Meeting Date:	September 6, 2023	Meeting Title:	Planning Commission
Submitting Department:	Planning Department	Presenter:	Katelyn Page
Agenda Item:	P23-105 Development Plan for a new 3-story mixed use building at the properties addressed 655 and 665 S. Cache Street	Public Comment:	Yes

Permit # P23-105 Parcel # : 22-41-16-33-1-69-005
Site Address: 665 S CACHE STREET
Project Name: Development Plan - 665 S. Cache St.

CONDITIONS	DEVELOPMENT REVIEW APPROVED WITH CONDITIONS P23-105 Development Plan ADDRESS: 665 S Cache Street OWNER: Newjack, LLC APPLICANT: Hoyt Architects 8/21/2023 Scott Mohror, (307) 733-3079 DATE OF SUBMITTAL: 8/15/2023 DATE OF MATERIALS: 8/11/2023 REVISION NO.: 01 The Engineering Division has reviewed your application for a DEVELOPMENT PLAN submitted on and with application materials as dated above. *The following comments are being provided for use in preparation of future applications and are required for sufficiency. CONSTRUCTION MANAGEMENT PLAN 1. Response to Department Reviews dated August 11, 2023, Engineering Reviews addresses the original engineering review comments with acknowledgement comments. 2. Engineering understands the CM Plan at this stage is not ful

EX1.0

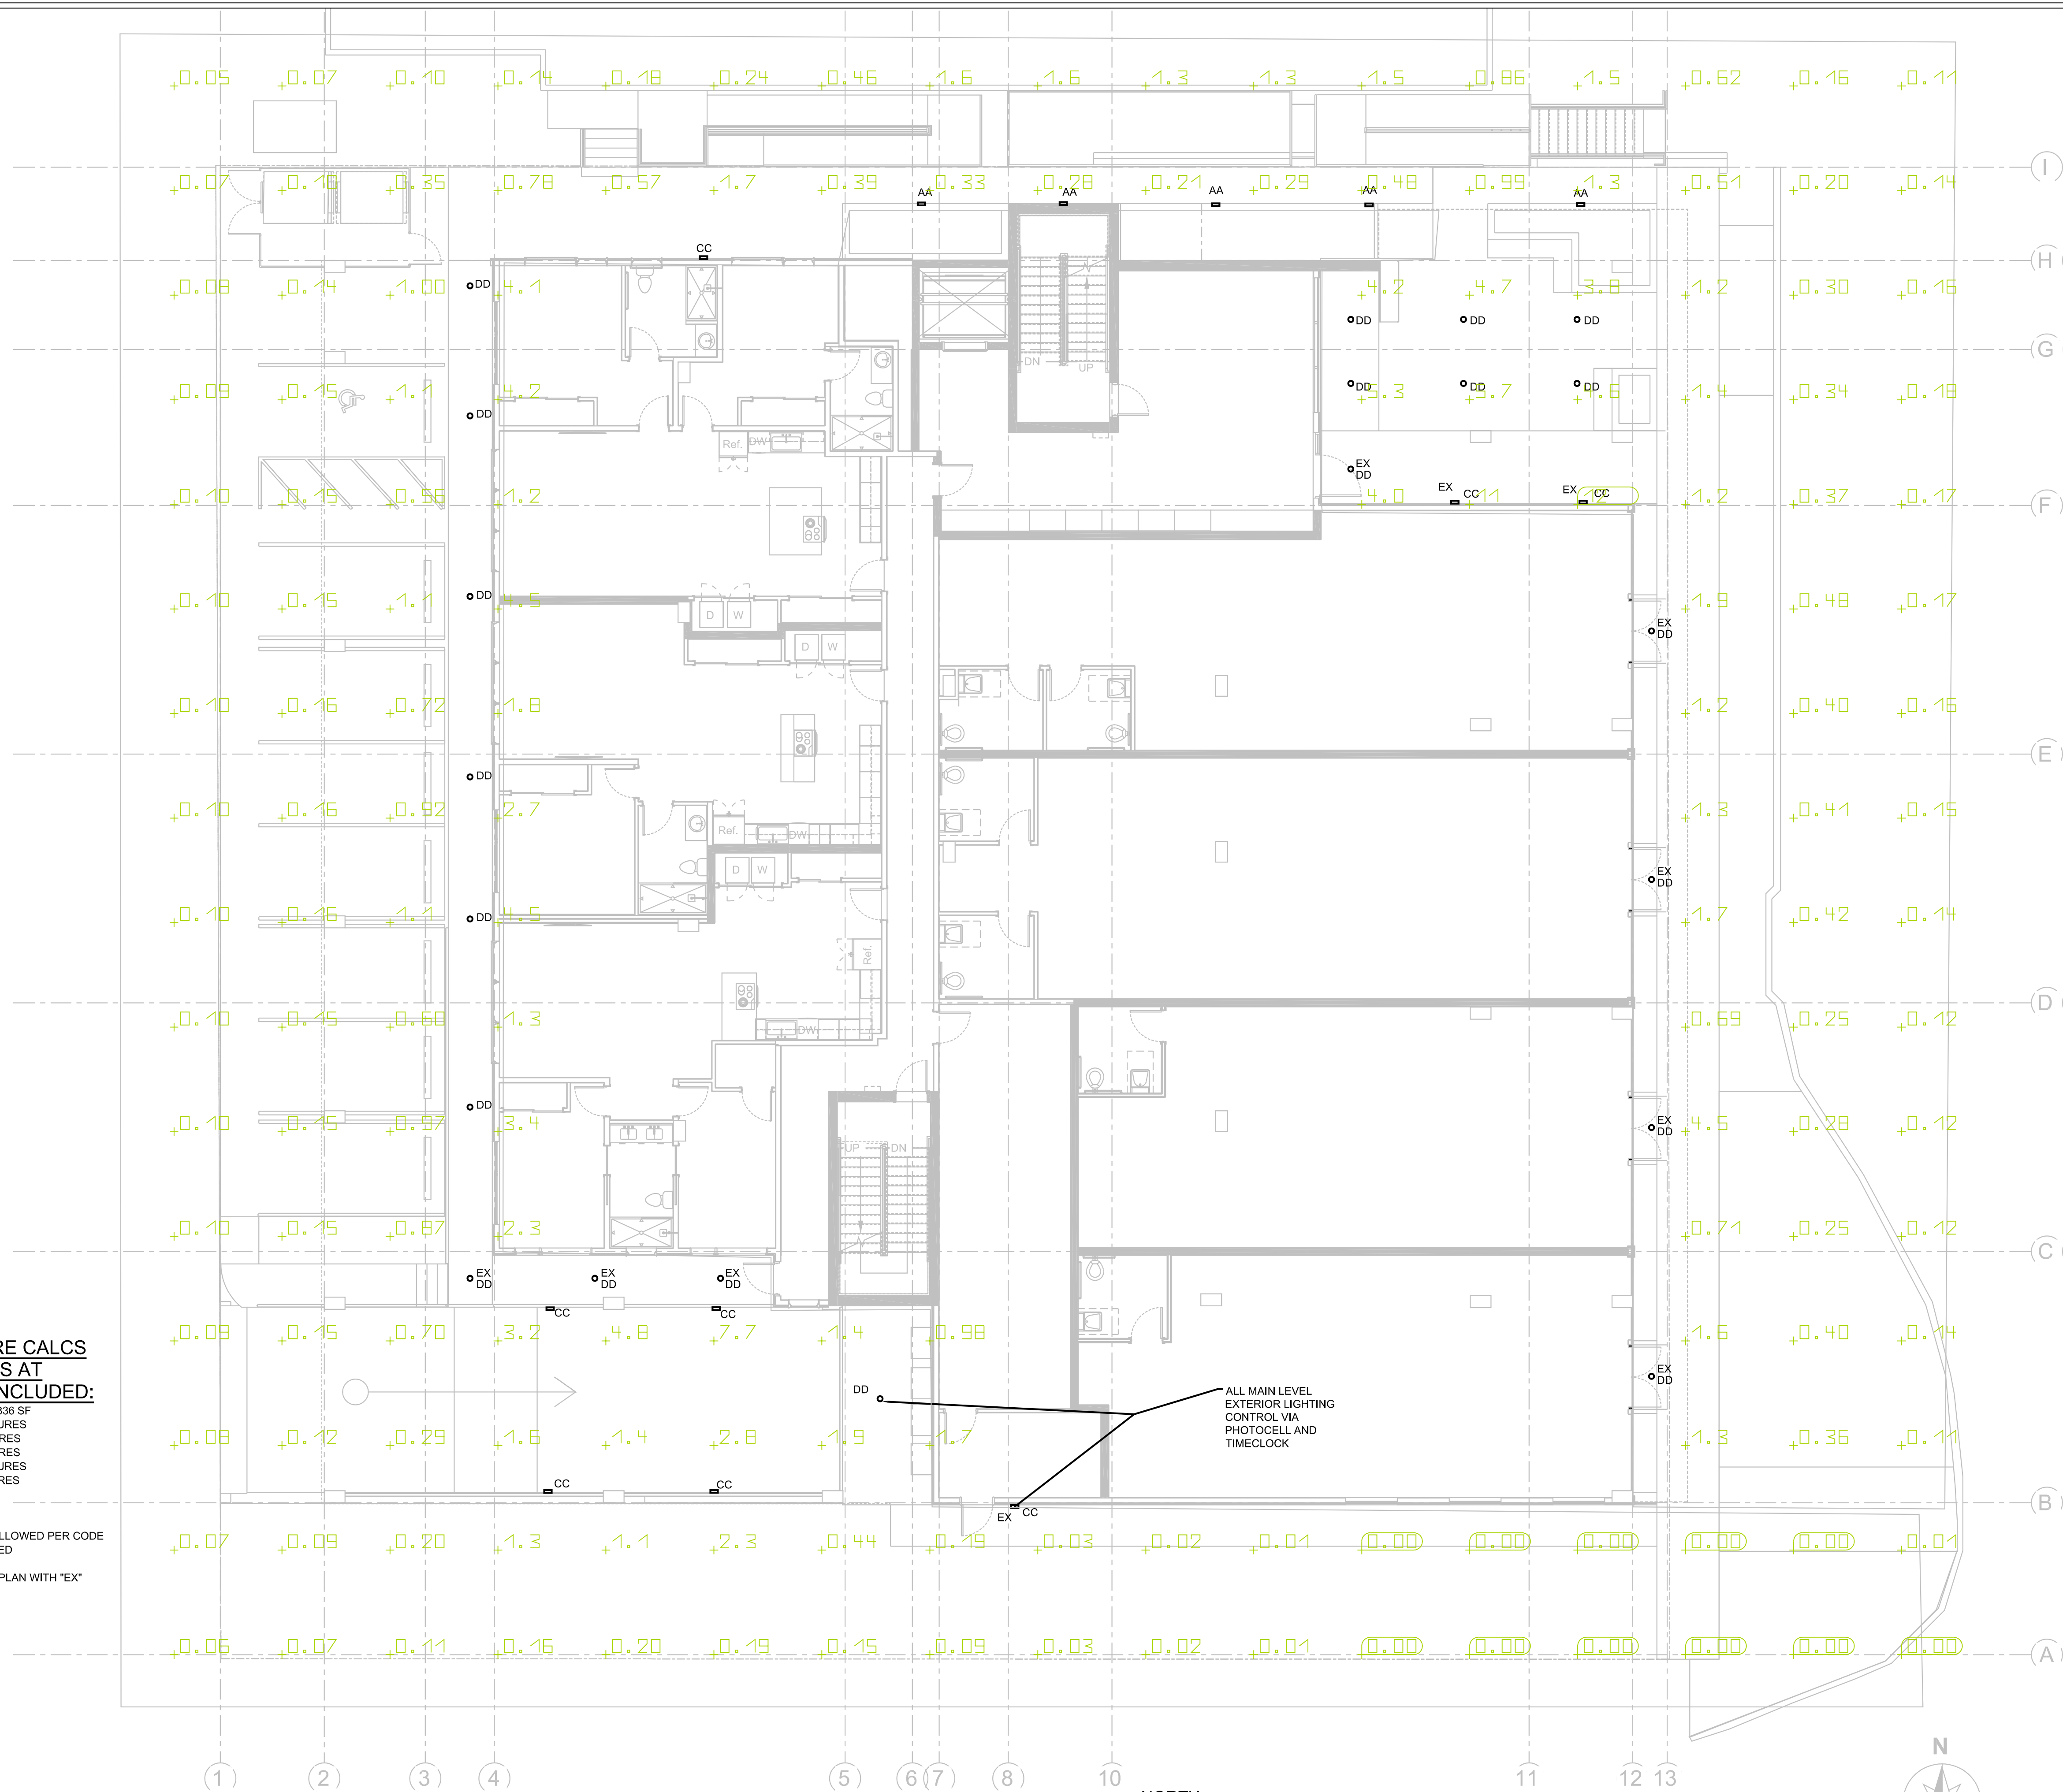
EX1.0 Revise lighting plan to show compliance with lumen maximum. LDRs were updated in 2022 for lighting standards. Based on site acreage of 0.46, the CR-1 zone is allowed a maximum of 3 lumens per sf of site development but is limited by a maximum of 50,000 lumens per acre of site development for all fixtures and a maximum of 2000 lumens per acre of site development for unshielded fixtures. All lights over 600 lumens shall be fully shielded and light color may not exceed 3000 kelvin. Staff requires the site development area in order to confirm maximum lumens, however, it is likely it will be closer to half the amount currently proposed.

EX1.0 –Revise lighting plan to show compliance with lumen maximum. LDRs were updated in 2022 for lighting standards. Based on site acreage of 0.46, the CR-1 zone is allowed a maximum of 3 lumens per sf of site development but is limited by a maximum of 50,000 lumens per acre of site development for all fixtures and a maximum of 2000 lumens per acre of site development for unshielded fixtures. All lights over 600 lumens shall be fully shielded and light color may not exceed 3000 kelvin. Staff requires the site development area in order to confirm maximum lumens, however, it is likely it will be closer to half the amount currently proposed. Revise plans to include total amount of site development so staff may verify above lumen maximums.
